Submission to the CNSC by the
Canadian Coalition for Nuclear Responsibility

Regarding the Darlington New Nuclear Project (DNNP)
and the documents provided in support of
siting one of four BWRX-300 reactors
at the existing Darlington NGS site

Submitted March 20 2023

[Part 2](#). A Review of the EIS and PPE for OPG's DNNP.

FIGURE 2.5 Comparison of atmospheric releases of noble gases for selected BWRs (left) and PWRs (right) in the United States. The units on the vertical scale are in gigabecquerels (GBq = 0.03 Ci). SOURCE: Data from the United Nations Scientific Committee on the Effects of Atomic Radiation (UNSCEAR).

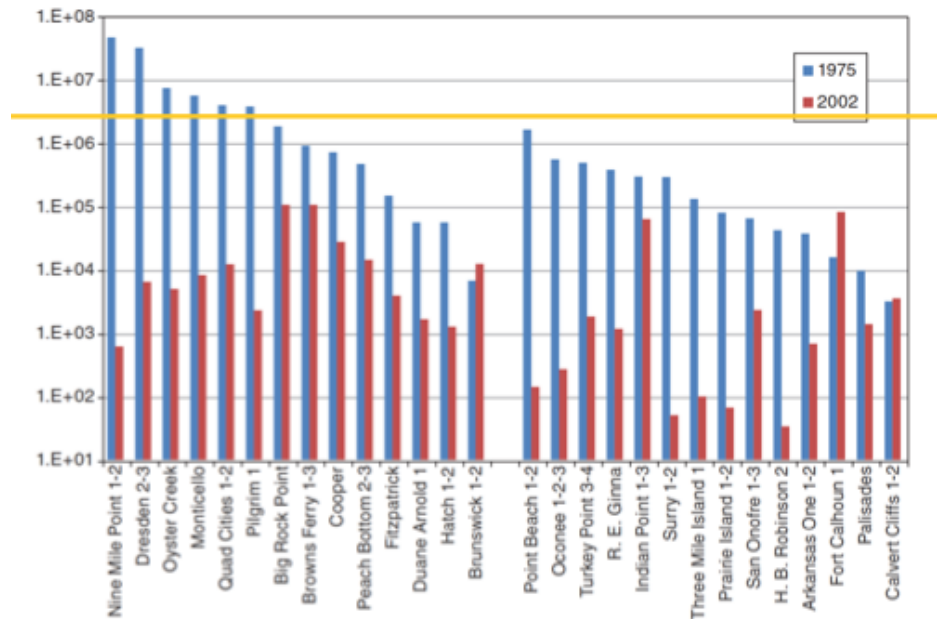
It is troubling that OPG would omit listing the total noble gas emissions in both tables of PPE-2. After all, the BWRX-300 is the only boiling water reactor ever considered in the context of this pre-licensing process.

But even if the appropriate numbers had been given, it would not be enough. You cannot judge the environmental impact of radioactive noble gas emissions just by the number of becquerels released each year. These gases are considerably heavier than air. They have to be released at a great altitude to minimize the gamma dose (“sky shine”) to people and animals on the ground below.

But, the BWRX-300 reactor is underground and the building does not reach as high (35 m) as any of the other reactors previously considered in the PPE (typically around 48 m). So the possibility of a near-ground release cannot be excluded. That would be problematic.

The BWRX-300 Reactor – Much Ado About Siting

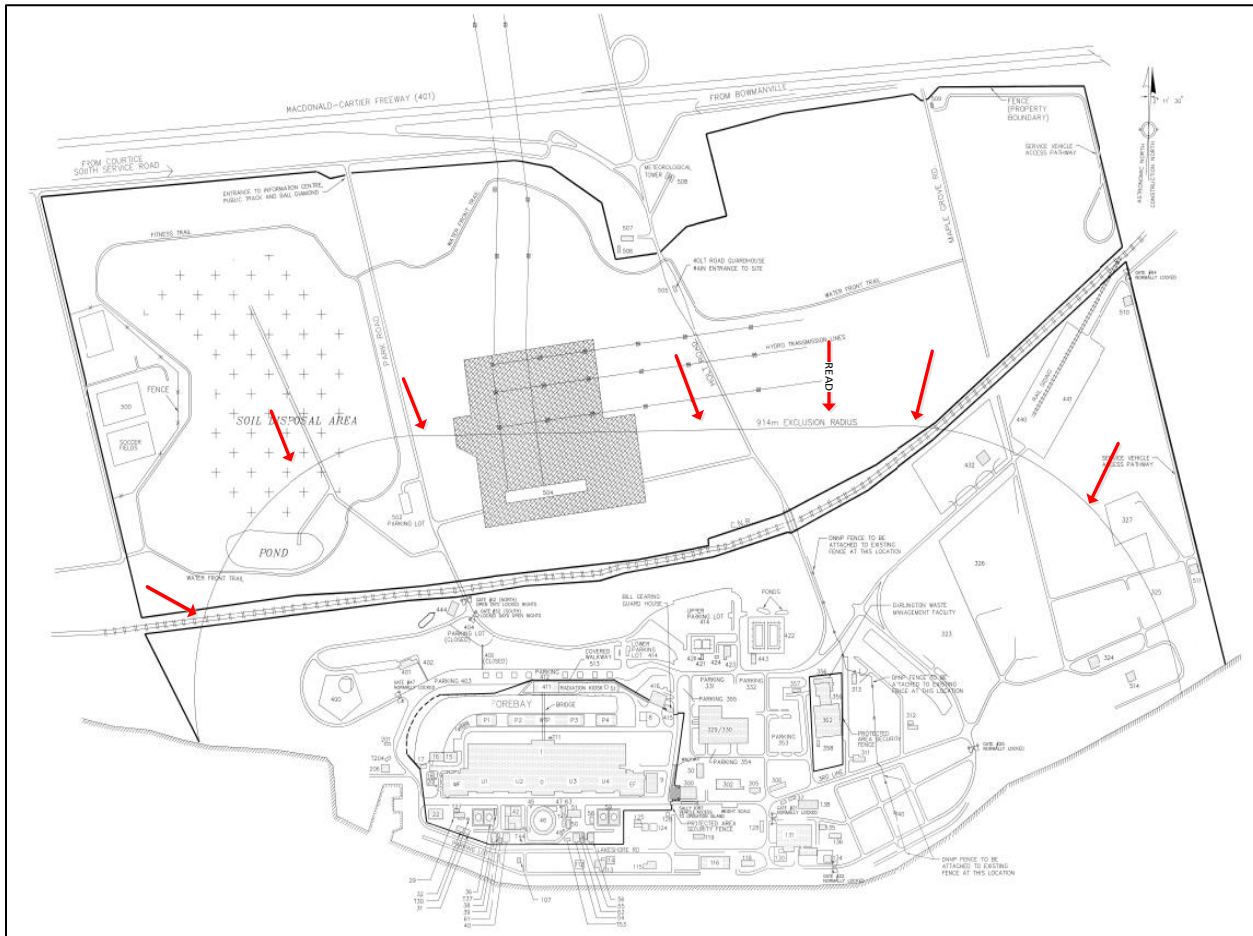
In these two images, the dotted lines indicate the boundary of the exclusion zone. The first image is from 1978, the second is from the 2012 Darlington Safety Report.

The DNGS exclusion zone was subsequently redrawn, without commentary, taking in a much smaller area.

Some of the space previously allocated to DNGS B has now been reassigned for the storage of nuclear waste.

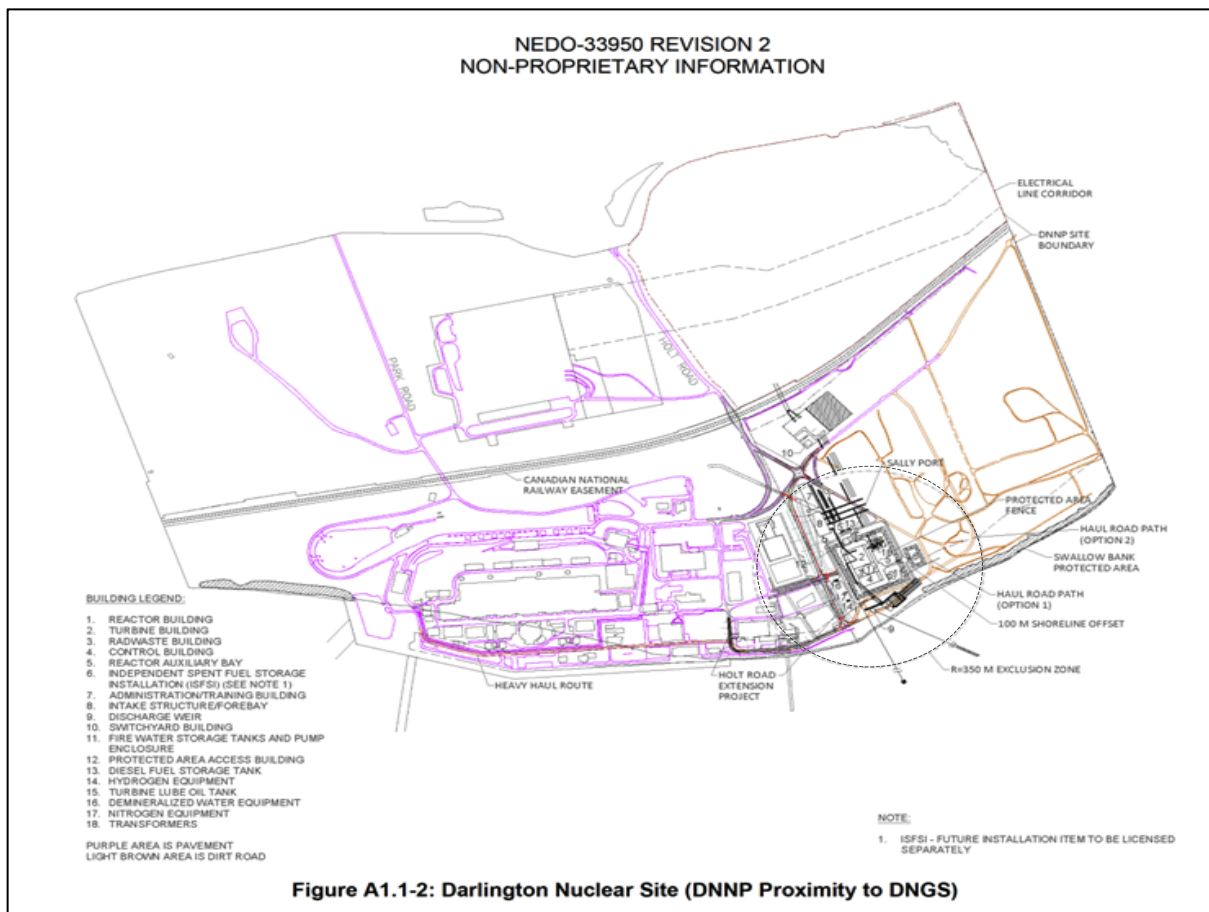
In each of these two diagrams, green circles represent the boundary of the exclusion zone.

In the aftermath of the Fukushima triple meltdown of 2011, we have a better understanding of the dangers of co-locating reactors. It is perhaps a blessing in disguise that DNGS B never got built. Be that as it may, OPG and CNSC are now considering up to 4 new reactors of the BWRX-300 variety to fit into this rather crowded space, with spent fuel dry storage facilities now occupying some of the space originally intended for DGNS B.

It appears that the first BWRX-300 will be right inside the redrawn DNGS exclusion zone, Its own exclusion zone (circle below, radius 350 m) largely overlaps the one from DNGS.

In light of the lessons we have learned from Fukushima, CCNR believes it is unacceptable to have a new reactor built inside the exclusion zone of an existing reactor. In the event of a severe accident at one or more of the existing Darlington reactors, the entire construction crew of 1,000 to 2,000 workers could receive radiation exposures greater than 25 rems (250 mSv) within two hours. There is no reason to expose the workers to such a risk. They are not even classified as radiation workers.

7. That OPG be required by CNSC to derive science-based exclusion zones for both Darlington NGS and for the proposed BWRX-300 reactor according to the criteria laid out in U.S. NRC document 100.11.
8. That no new reactor be allowed by CNSC to be built within the exclusion zone of any other existing reactor.
